IDAP REPORT

Property:	21 Palmer Avenue, Strathfield Lot A in DP 385385 DA2021/251
Proposal:	Construction of a two (2) storey dwelling house.
Applicant:	Crystele Designer Homes
Owner:	Zhihao Chen and Hanebei Tao
Date of lodgement:	27 September 2021
Notification period:	7 October 2021 to 21 October 2021
Submissions received:	Nil
Assessment officer:	L Fanayan
Estimated cost of works:	\$1,030,000.00
Zoning:	R2-Low Density Residential - SLEP 2012
Heritage:	No
Flood affected:	Yes
RECOMMENDATION OF OFFICER:	Approval

Figure 12: Western elevation showing conditioned changes to ceiling height above void and associated roof line

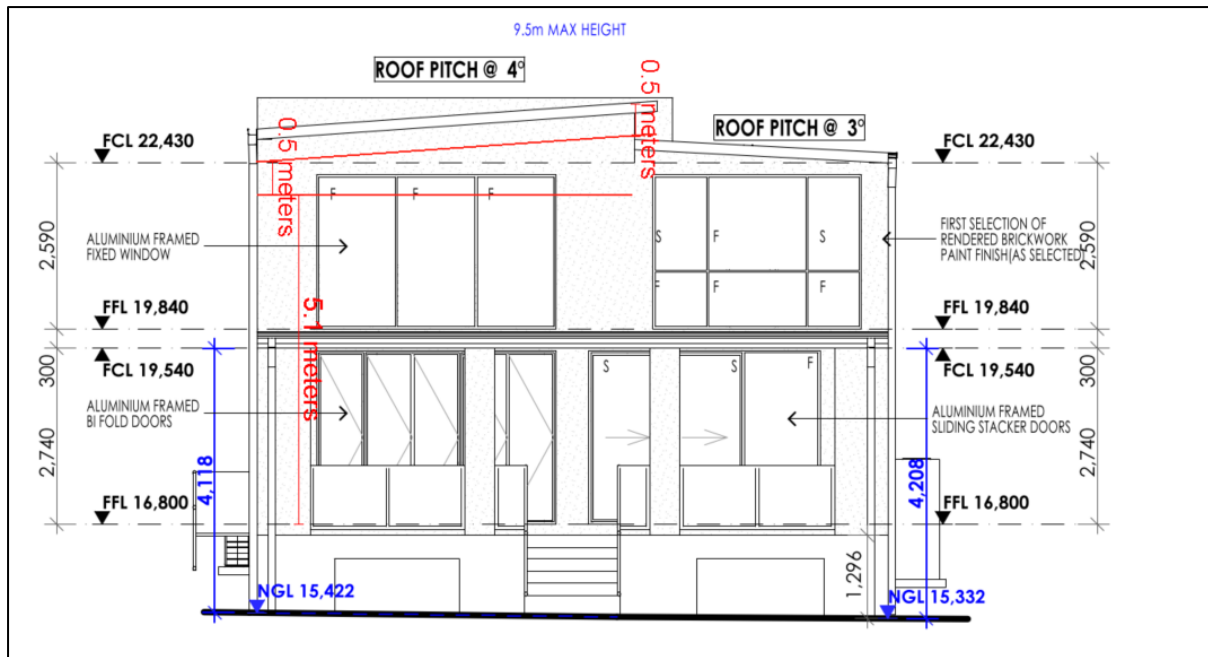
The amended design has not ameliorated the void spaces. Design changes will be conditioned to reduce the ceiling height over the dining room void area to remedy bulk and scale implications of void areas (see Figure 12 and 13).

It is noted that whilst the voids are not counted towards gross floor area and FSR it does contribute to the overall bulk and scale of the built form. The void over the lounge at the front of the dwelling will be accepted, however, the void over the dining room will be conditioned to have an overall ceiling height of 5.13m, a reduction of 0.5m (see Figure 12 and 13). This reduces unnecessary bulk and also ensures protects against infilling of void space with GFA in the future. The roof height above the void space is to be reduced accordingly.

Ceiling and building height	<p>Prior to the issue of a Construction Certificate, amended plans are to be submitted to and approved by Council which details the following:</p> <ul style="list-style-type: none"> - The ceiling height above the dining room is to be reduced by 0.5m (RL 21.93 AHD) creating a ceiling height of 5.13m. - The building height is to be reduced in response to the reduced ceiling height.
Alfresco finished floor level	<p>Prior to the issue of a Construction Certificate, amended plans are to be submitted to and approved by Council which details the following:</p> <ul style="list-style-type: none"> - Finished floor level of the alfresco area is to be reduced to RL 16.3 AHD.

Figure 14: Void spaces above dining room and lounge room

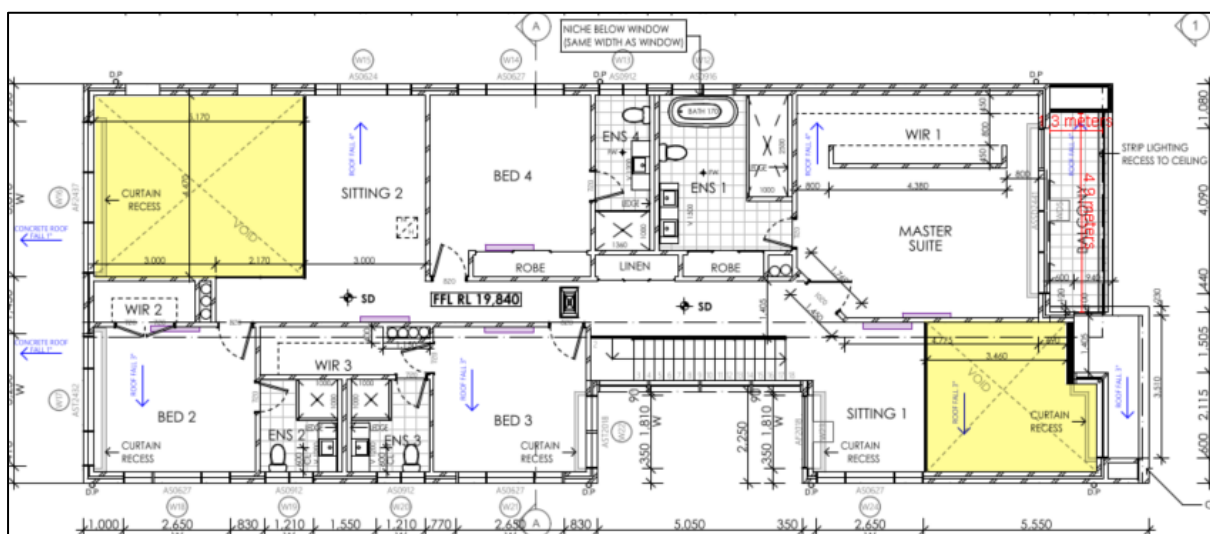
The void space over the lounge at the front of the dwelling will be accepted, however, the void over the dining room will be conditioned to have an overall ceiling height of 5.13m, a reduction of 0.5m. Both voids do provide additional solar access and amenity from the east into the lounge room and from the north into the dining room (refer to Figure 14). It is noted that voids contribute to bulk and scale however a reduction of ceiling height and associated roof height in the northern void over the dining room will assist in ameliorating impacts to the neighbouring property. On balance, with a reduction in the larger dining room void and the amenity they do provide these voids are accepted and considered reasonable.

To ensure that the void space above the formal dining room remains a void an ongoing condition will be included in the consent.
